Kennedy Space Center (KSC) Launch Complex 39 (LC-39) Gaseous Hydrogen (GH₂) Vent Arm Behavior Prediction Model Review Technical Assessment Report

Toma Turney	Technical Assessment Report	RP-05-114	1.0
Kennedy Space Center (KSC) Launch Complex 39 (LC-39) Gaseous Hydrogen (GH ₂) Vent Arm Behavior Prediction Model Review Technical Assessment Report		Page #: 1 of 32

NASA Engineering and Safety Center Technical Assessment Report Title: Kennedy Space Center (KSC) Launch Complex 39 (LC-39) Gaseous Hydrogen (GH₂) Vent Arm Behavior Prediction Model Review Technical Assessment Report

Figure 7.2-1 Haunch Pivot Arm Slots (HPAS)

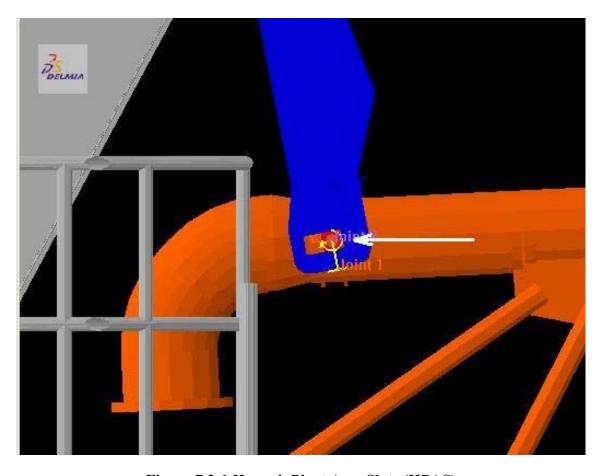
The second centering force occurs when the vent arm is not parallel with slots on the pivot arm. The Haunch Pivot Arm Slots (HPAS) develop contact force between the slider block, which surround the trunnions, as the vent pipe rotates down. The slots in the haunch pivot arm are initially parallel with the vent arm pipe while the GUCP is attached to the ET (refer to Figure 7.2-1). This allows the vent arm to yaw side to side to accommodate the motion of the ET just prior to Solid Rocket Booster (SRB) ignition ("twang").

The arrow indicates the contact force on the slider blocks from the retraction weights.

Figure 7.2-2. The HPAS at Approximately 40 Degrees to the Vent Arm Excursions in this position will cause the vent arm to roll and bend the aft flex base.

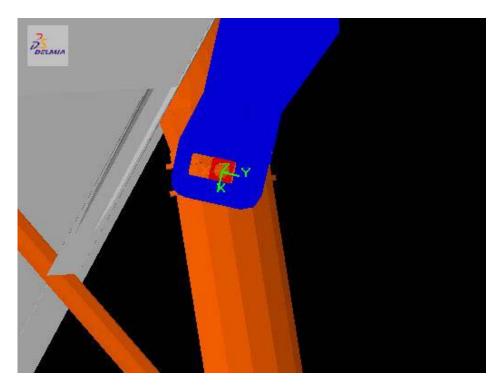
Once the pipe has rotated so that it is no longer parallel with the HPAS (refer to Figure 7.2-2), any clearance between with the HPAS and the slider block is initially bottomed out, and out-of-

plane excursions cause a contact force between the slider block and the top and bottom of the HPAS. This contact force bottoms-out one trunnion and drives the other trunnion up the HPAS, which will lift the retraction weights as in the first scenario. There will also be an associated vent pipe to roll along its axis, which will twist the aft flex line.

It is expected that the contact forces between the HPAS and the slider blocks vary substantially for different operational conditions and could have been very large. If the forces are large enough, the slider blocks, HPAS, and the bushings and/or bearings will be damaged. Periodic inspections and replacement of this hardware should catch visible damage, but tolerances between parts will vary. Wear and tear tolerances were reviewed subsequent to STS-108 and documented in the investigation report; this was not considered a significant factor in the anomaly.

Because of the system's sensitivity to torsion flexure of the pivot arm and potential clearances in the joints, it is recommended that a mechanical hanging (fish) scale be utilized to document the system stiffness on either side of the Deceleration Units of both Pads A and B (reference A-23 of KSC-5600-5969).

Figure B.2. Pivot Arm Flexure Sensitivity

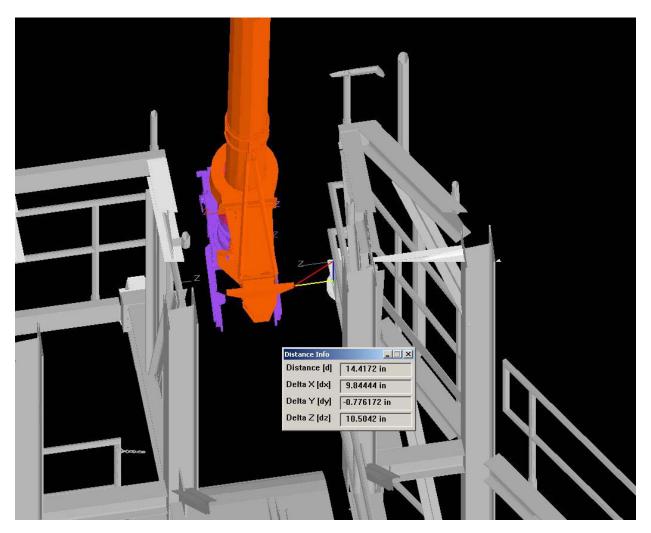
The out-of-plane excursions of the vent pipe, as it enters the deceleration unit, are sensitive to torsional flexure of the pivot arm and to any slope in the pivot arm to slider block joint or the slider block to trunnion joint. These sensitivities are illustrated in Appendix B.

End of vent arm clearance with the Deceleration Unit when the pivot arm is flexed 3 degrees from joint with FSS and joint with Slider Block. Clearance is reduced from 19.07" to 10.5" on the modified Deceleration Unit.

Figure B.3. Joint Stop Sensitivity

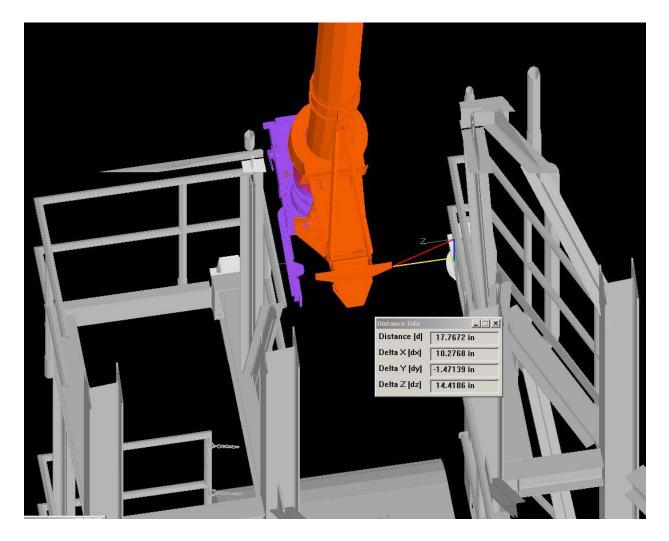
End of arm clearance with the Deceleration Unit when the two joints between the pivot arm and the Slider Block and the Slider Block and the Trunnions have a combined slope equal to one degree. Clearance is reduced from 19.07" to 14.41" on the modified Deceleration Unit.

Figure 1: Pivot Arm FE Model

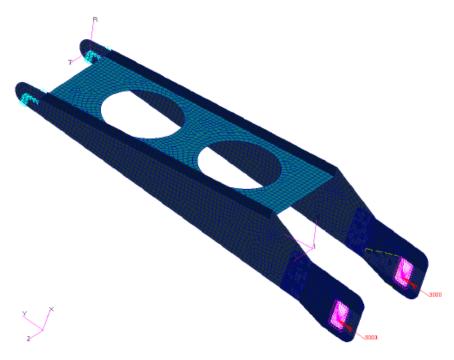
A Finite Element (FE) model of the pivot arm was created using MSC PATRAN®. The FE model was subjected to a known torque at the cross-section corresponding to the interface of the pivot arm and pivot arm shocks. The resulting angular rotation at this cross-section provides the stiffness for the first section of the pivot arm (stiffness between hinge and shock interface location) using the formula $K = M/\theta$. This approach was then repeated by applying a torque at the trunnion location. The angular rotation at the trunnions was then used to compute the overall stiffness of the pivot arm. From the following relationship, the second section stiffness (stiffness between shock interface location and the trunnions) can be computed as: $1/K_t = 1/K_1 + 1/K_2$. These stiffnesses were then compared to those used in the KSC AT-451.

The calculated stiffnesses were 38 percent lower for the first section stiffness and 20 percent lower for the second section. This difference was discussed with Roy Burton of USA. It was stated that the pivot arm stiffness had to be adjusted by this amount to correlate drop test timing results with the model. Pictures of the FE model and the associated calculations are provided in Appendix C.
